**Environmental
Planning
Commission**

**Agenda Number: 11
Project Number: 1003859
Case Number: 17EPC- 40017, 40028
Hearing Date: September 14, 2017**

Staff Report

Agent	Consensus Planning
Applicant	Silverleaf Ventures
Request	Amend SPS and SPBP
Legal Description	Tracts 1-4, 5A,5B, and 6 of North Andalusia at La Luz,
Location	SE corner of Coors Blvd. NW and Montaña Rd. NW
Size	Approximately 70 acres. zoned SU-1 for C-2 (23.3 acres max), O-1 (11.7 acres max), PRD (20 DU/AC) and O-1 with Bank including drive up services,
Existing Zoning	
Proposed Zoning	Same

The requested amendment to General Note #6 is as follows:

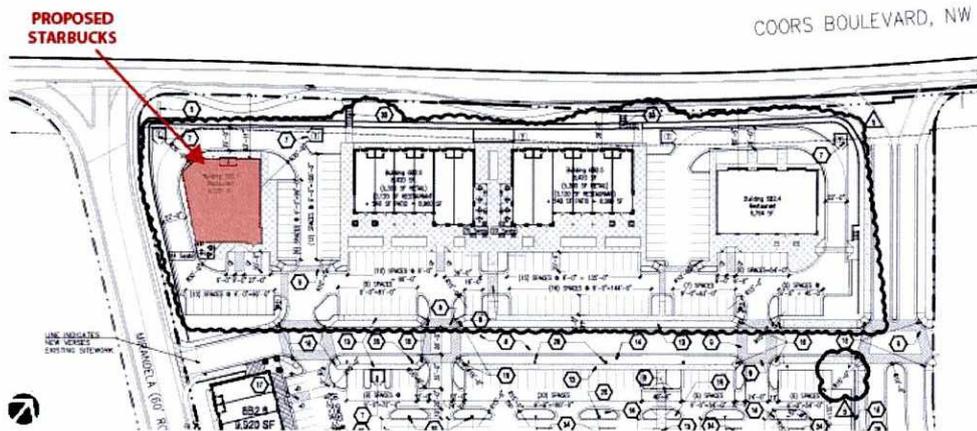
The applicant is proposing a minor amendment to the General Notes on the approved Site Plan for Subdivision, Sheet 1. General Note #6 was included based on the May 20, 2005 Notice of Decision. Finding #20 and Condition #2 reference an agreement with the neighborhood.

No fast food restaurants with drive through windows or gas stations are allowed at North Andalusia.

**PROPOSED
STARBUCKS**

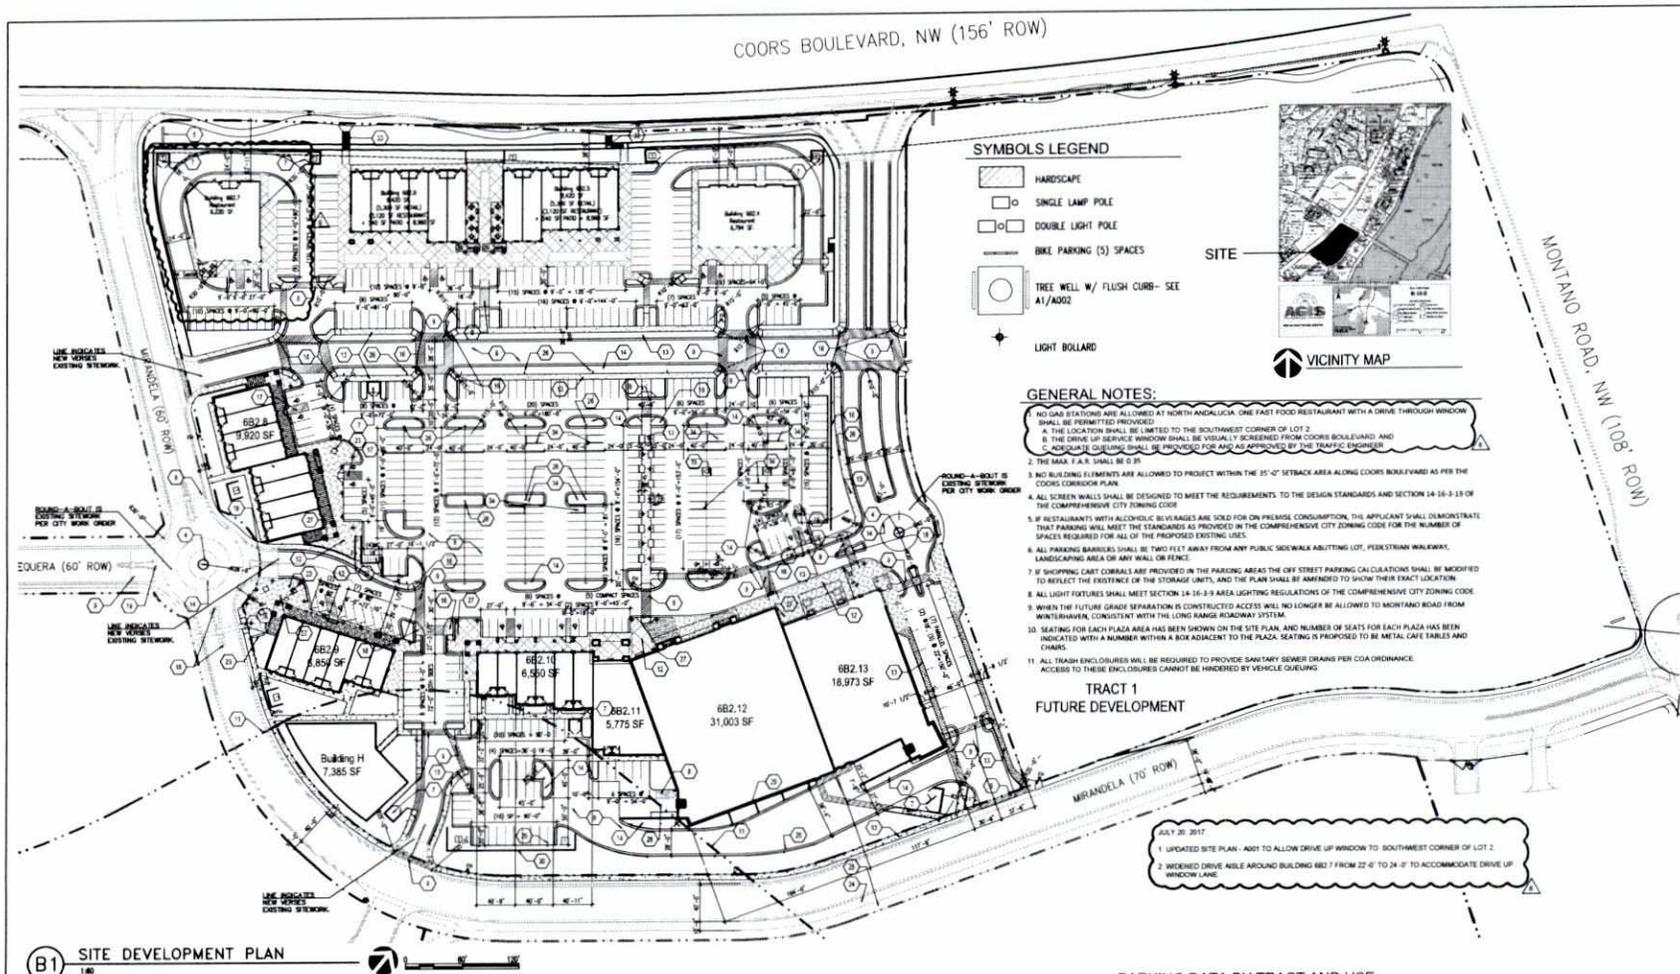
Staff was concerned that the 2017 AA (16 AA-10121) that added the proposed building shows the half circle drive as access for Solid Waste Vehicles, if the drive thru is approved how will solid waste access the site?

The half circle drive (service aisle) is currently approved as a 22-foot-wide service aisle that allows one-way traffic. The aisle will have to be widened to 24 feet in order to accommodate the single lane of drive thru traffic and the Solid Waste Vehicles (two-way travel). Included with this memo is the Site Plan Dimensions sheet showing the approved route for the Solid Waste Vehicles with the drive aisle expanded to 24 feet.

The applicant proposes to amend the SPBP to remove the note prohibiting drive up service windows and to increase the width of the service drive around building 6B2.7 from 22 feet to 24 feet to allow for both Solid Waste vehicles and cars using the drive up service window.

The proposed drive through wraps around the building, with the bulk of the drive through located behind the building. This configuration does move some of the traffic away from the front of the building where pedestrians would enter and exit. The drive through crosses the main pedestrian path from Mirandela Road. The plan does not indicate if this will be the entrance or the exit for the drive through.

If the request is approved, the Landscape Plan, Grading and Drainage Plan, Utility plan and Elevations shall be amended to reflect the change in width for the service drive for building 6B2.7.
